## Korenix JetNet Industrial Managed Switch 5010G SOFTWARE RELEASE Notes

JetNet5010G Firmware Release Note

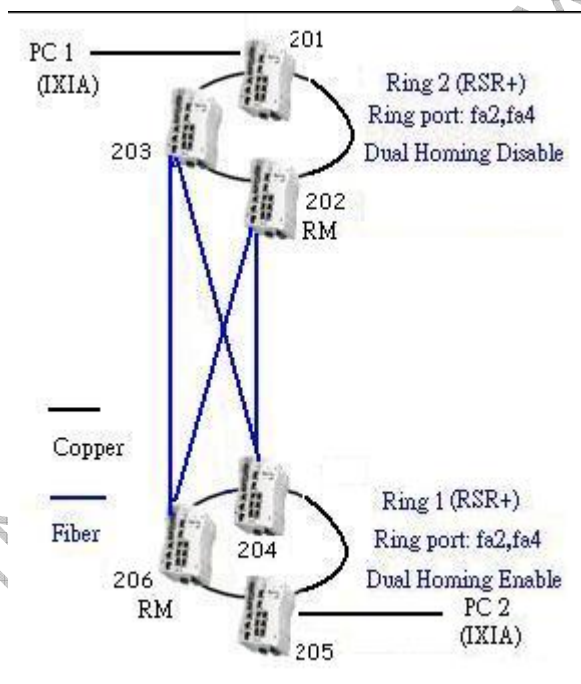
- Rename Rapid Super Ring to Multiple Super Ring with various features as following diagram.
